DECISION OF THE PLANNING ADMINISTRATOR

SUBDIVISION TENTATIVE PLAN / URBAN GROWTH PRELIMINARY DECLARATION CASE NO.: SUB-UGA23-07

SUMMARY: A consolidated application for a proposed five-lot subdivision (Clutch Acres).

SUBDIVISION PLAN

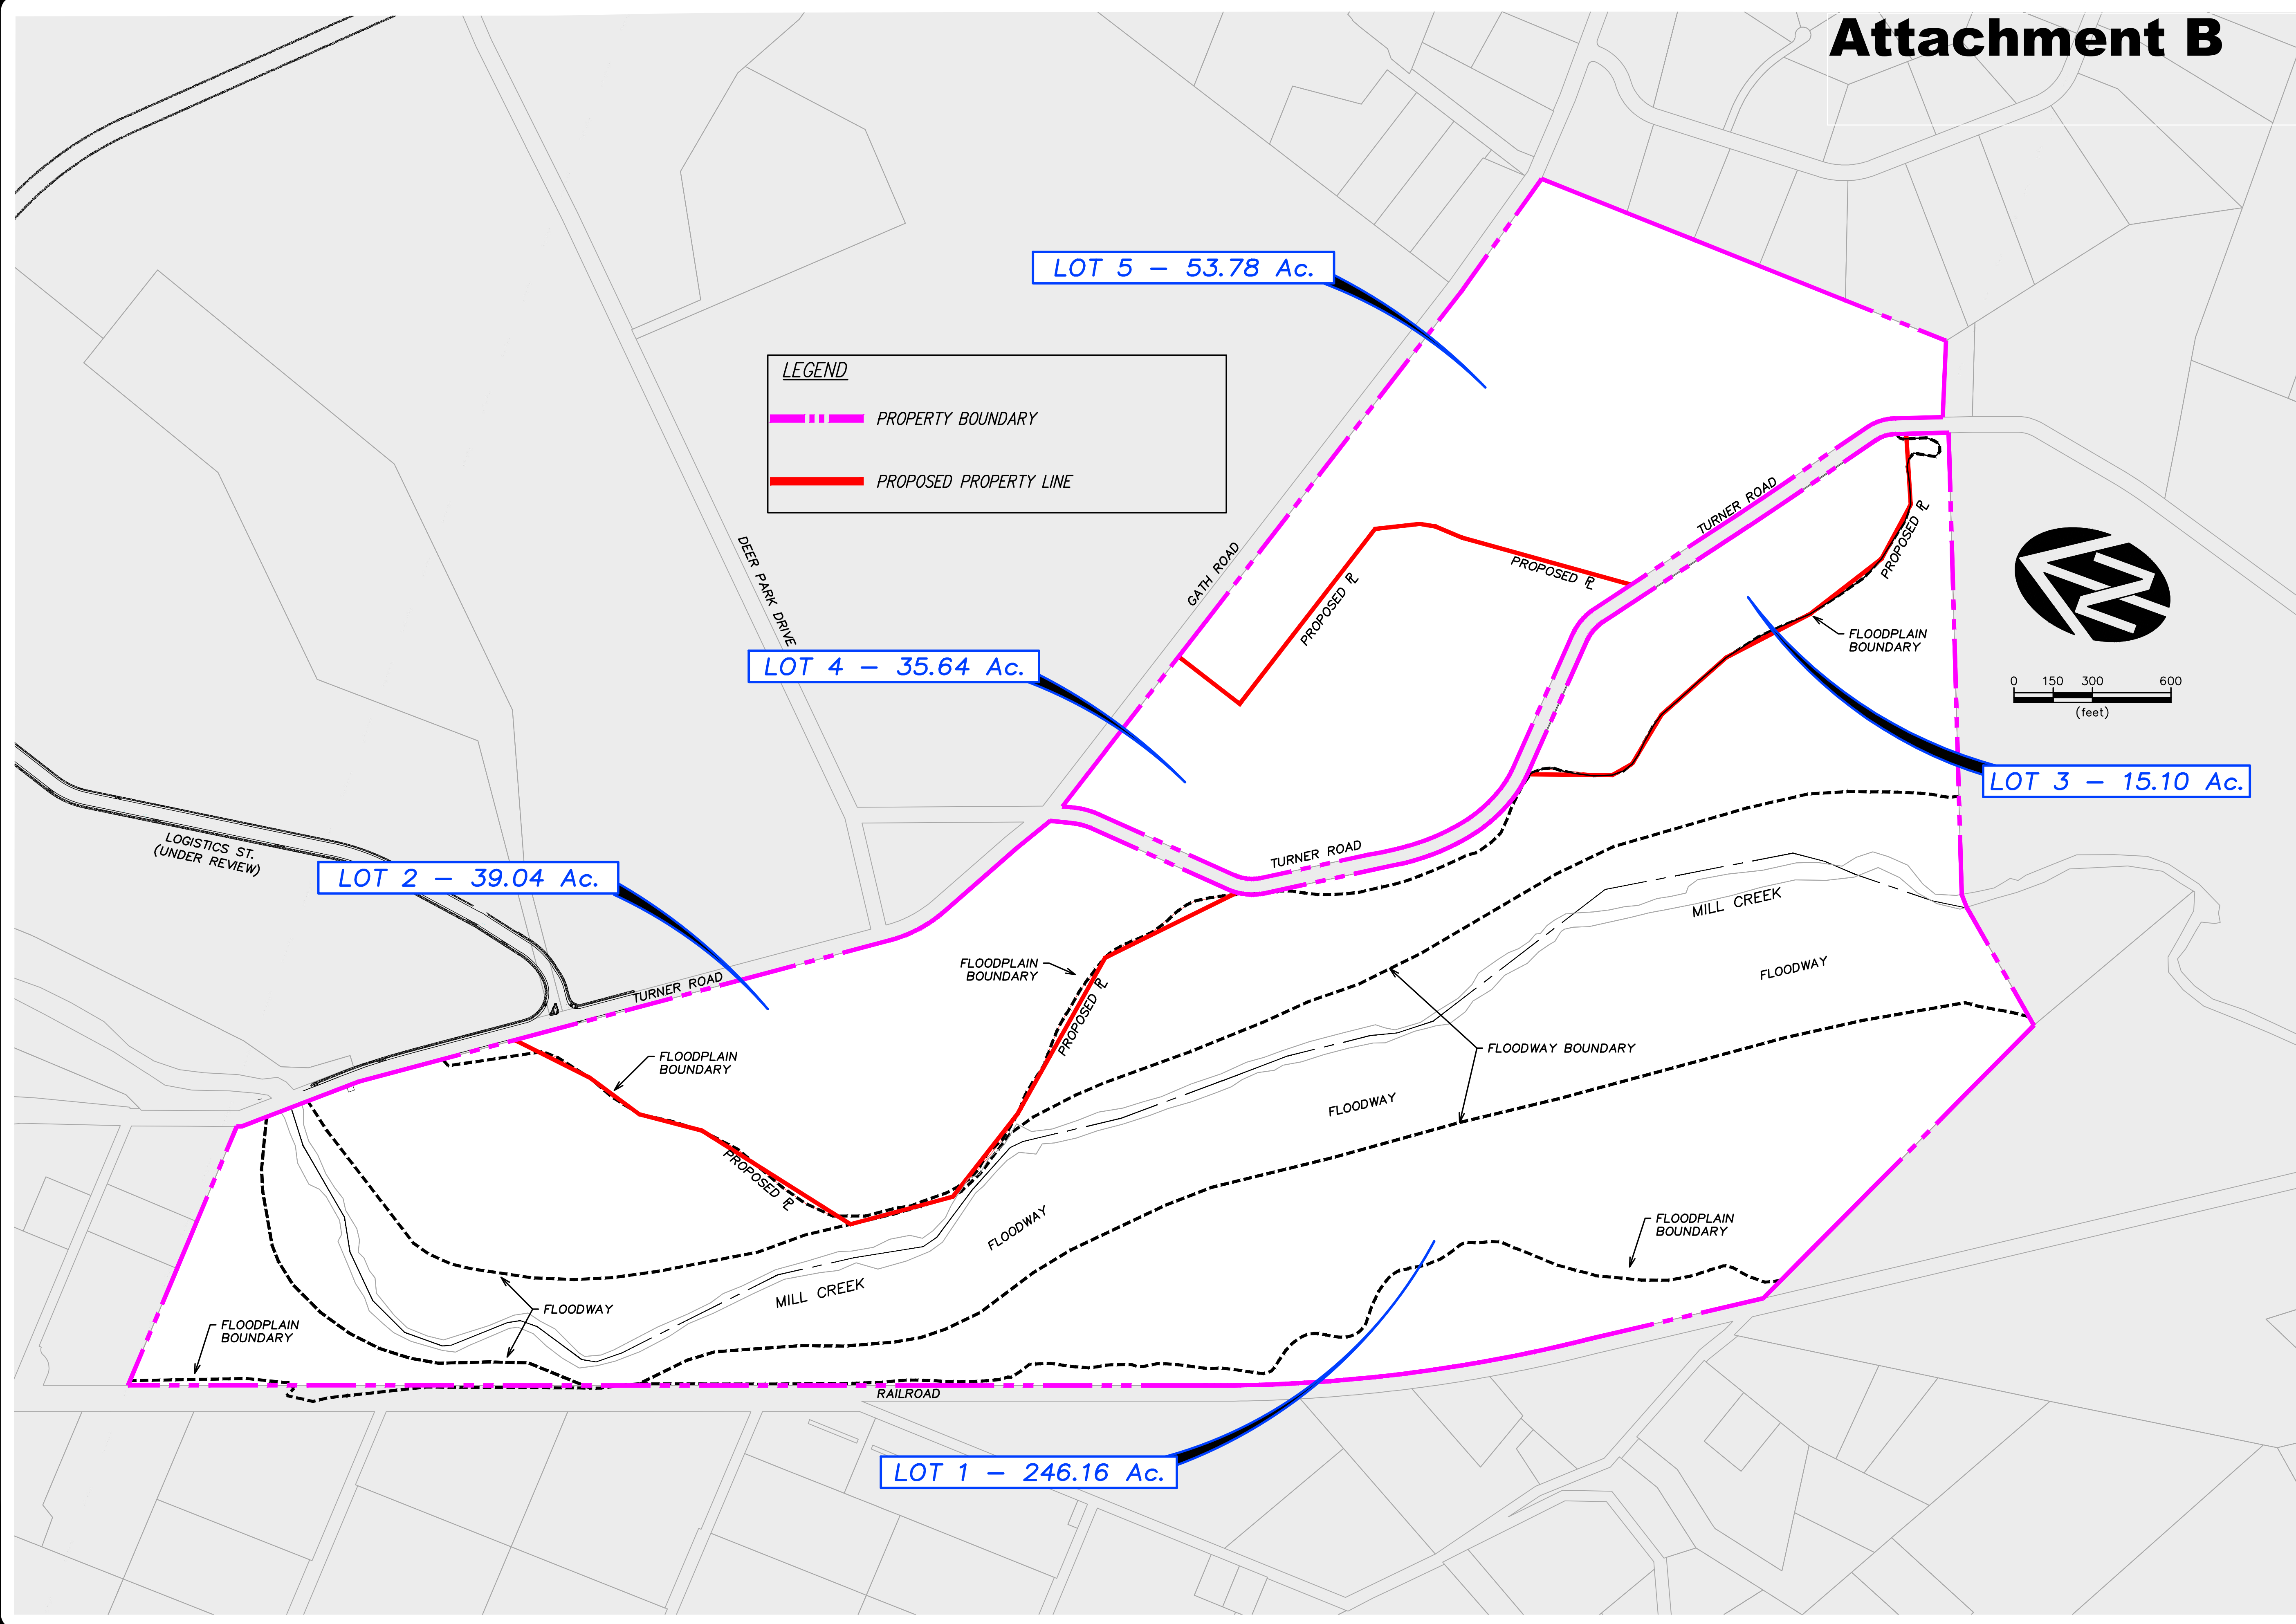
As shown on the tentative subdivision plan (**Attachment B**), the lot sizes of the proposed five lots within the subdivision range from approximately 15 acres to 246 acres; therefore, exceeding the minimum lot area standards of the PS zone.

The application does not meet minimum street connectivity, block spacing, or other minimum street standards established in SRC Chapter 803. The purpose of the application is to divide approximately 390-acres into five-lots for future development. At time of future development through Site Plan Review or further land division application, staff will review the proposed development layout to ensure minimum street design standards are met, unless a Design Exception or Alternative Street Standard is approved. Nothing in this decision precludes future development from complying with current standards.

Findings: The applicants tentative plan does not comply with minimum submittal requirements established in SRC Chapter 205. The applicant shall provide the required field survey and subdivision plat per Statute and Code requirements outlined in the ORS and SRC. The applicant is advised that the subject property appears to have several easements that shall be either shown on the final plat or the interest released prior to final plat. If said documents do not comply with the requirements outlined in ORS and SRC, and as per SRC Chapter 205, the approval of the subdivision plat by the City Surveyor may be delayed or denied based on the non-compliant violation. It is recommended the applicant request a pre-plat review meeting between the City Surveyor and the applicant's project surveyor to ensure compliance with ORS 672.005(2)(g)&(h), 672.007(2)(b), 672.045(2), 672.060(4), and *Oregon Administrative Rules* 850-020-0015(4)&(10), 820-020-0020(2), and 820-020-0045(5).

Condition 1: The application shall provide the required field survey and partition plat as per the statute and code requirements outlined in the Oregon Revised Statutes (ORS) and the Salem Revised Code (SRC).

Condition 14: Prior to development or further land division, provide a 34-foot linking street improvement from the development site to the Mill Creek Bridge.
